## ADDENDUM NO. 2

**TO: PLANS AND SPECIFICATIONS FOR STATE OF MISSOURI**

**Lewis and Clark State Park - New Premium Campsites  
Missouri State Parks West Region  
Rushville, Missouri  
PROJECT NO.: X2219-01**

**2 VALVE BOX - CAMPSITE**  
C18 NTS

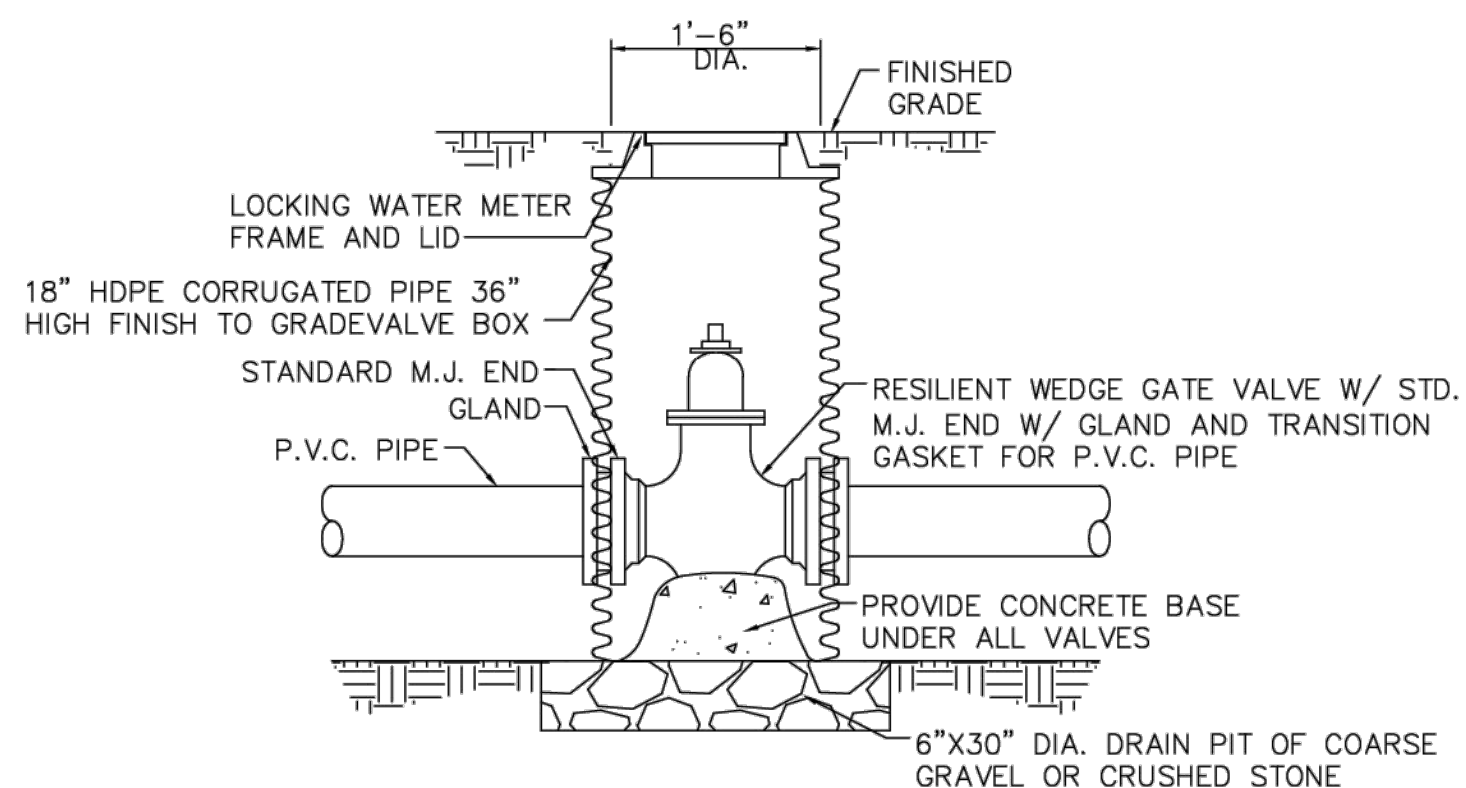
1. **Sheet C-505, Detail 2 Valve Box**, refer to revised detail attached.
2. **Sheet C-103, Pavement Plan** – add alternate 1 has been added. Refer to revised sheet attached.

- NOTE:**
- WHEN GATE VALVE IS INSTALLED IN EXISTING DUCTILE OR C.I. PIPE, REPLACE TRANSITION GASKET W/ STANDARD M.J. GASKET.
